**PUBLIC HEARING/WORKING SESSION MEMORANDUM**

**PETITION #63-15**

**15 Holman Road**

Request for Special Permit/Site Plan Approval to Extend a Nonconforming three-story structure and to exceed the allowable maximum Floor Area Ratio (FAR).

**ATTACHMENT A:** Revised Site Plan

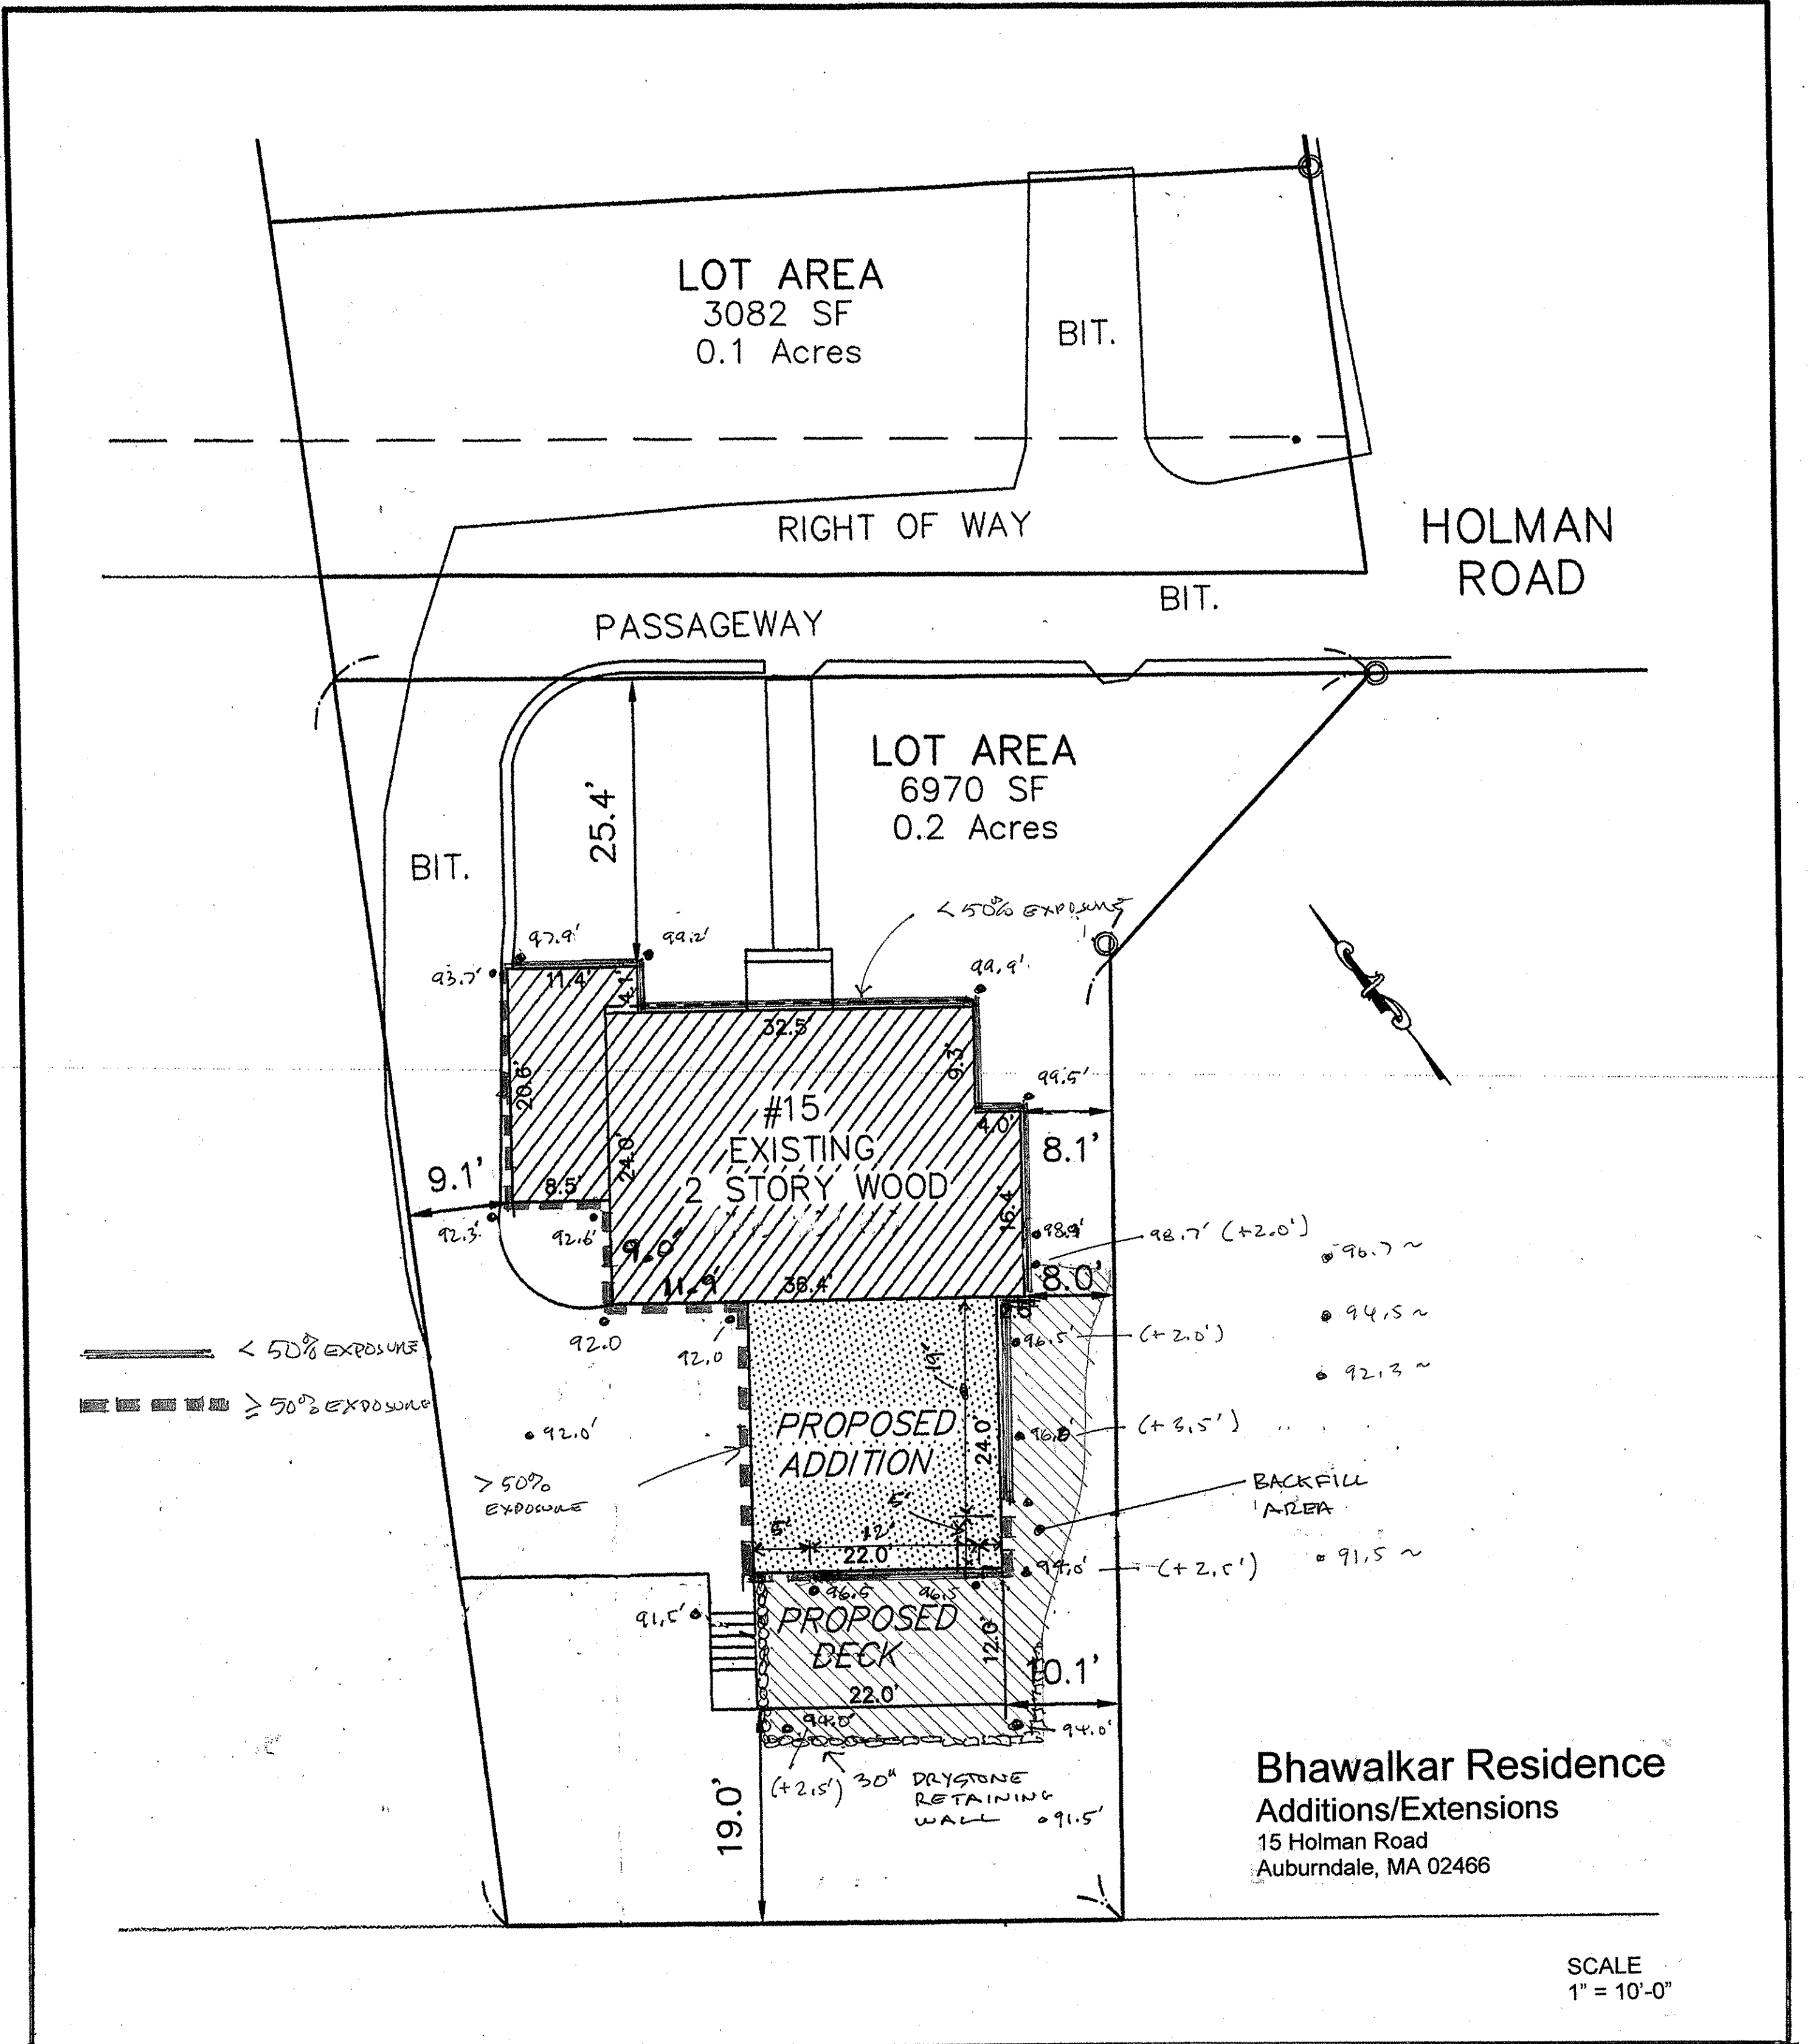
The petitioner submitted a site plan showing increases in the grade at the rear of the structure under the deck and along the eastern side of the addition. The petitioner is proposing to fill in the area under the deck, which will require a retaining wall of approximately 2.5 feet. The grading on the eastern side of the addition will result in an approximately 2 to 3.5 foot increase in grade along the side of the structure. The grading will maintain a downward slope from the front to the rear of the property.

Staff discussed the grade change with the City Engineer to ensure that the proposed grading would not adversely affect the abutting lots. The City Engineer was not concerned with the additional fill under the deck, and believed that the grading along the eastern property could be modified slightly to ensure that existing runoff patterns are not altered. The City Engineer will conduct a site visit with staff and the petitioner prior to the public hearing/working session. The Planning Department believes that any necessary modifications to the proposed grading can be addressed with the City Engineer through the building permit process.

2. All landscaping and fencing shall be maintained in good condition and shall be replaced with similar materials as necessary.
  3. The petitioner shall submit an final grading plan to the City’s Engineering Division of the Department of Public Works for their review and approval.

# FAR Compliance Documentation

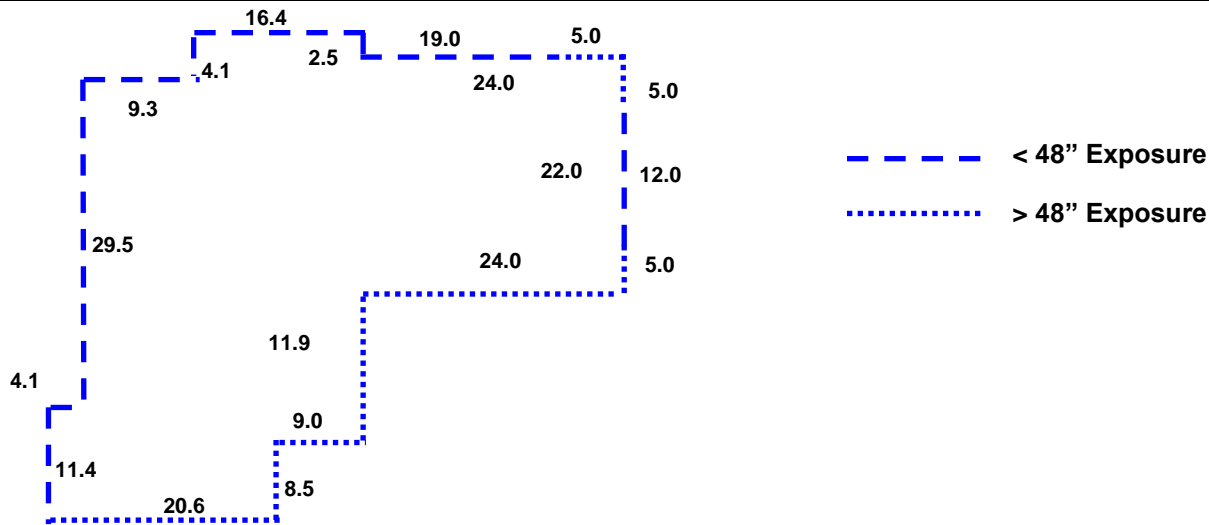
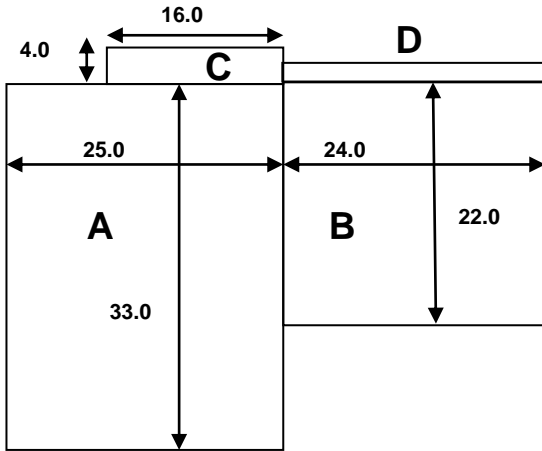
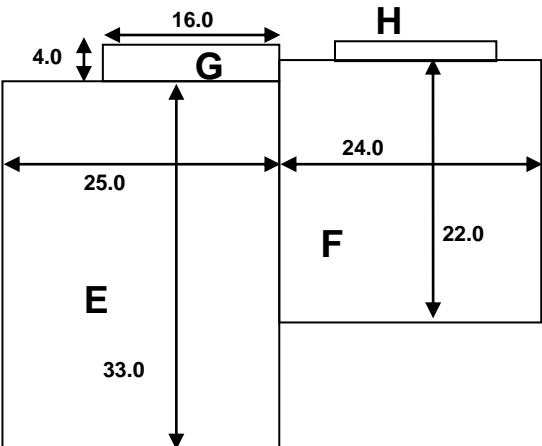
At the previous public hearing/working session, the Committee asked how the proposed grading impacted the calculation of the number of stories and the FAR. Based on the petitioner's revised calculation for the number of stories, ½ of the basement height continues to be above the average grade plane. As such, the structure continues to be considered three stories under the Newton Zoning Ordinance, and requires a special permit.

The revised FAR calculation reduces the square footage counted in the basement by approximately 24 square feet (from 727 square feet to 703 square feet), if the petitioner uses the "X/Y<sup>1</sup> \* the floor area of mass below first story" calculation in the FAR definition instead of the "50% of the floor area of mass below first story". The reduction decreases the FAR from .5183 to .5143. The "50% of the floor area of mass below first story" is the calculation used to determine the FAR of .5183 and is the more conservative approach. The Planning Department recommends using the more conservative approach, as a slight modification in the grading could change the portion of the basement exposed by more than four feet.

Based on the revised calculation of the number of stories and FAR, there is no change to the relief requested.
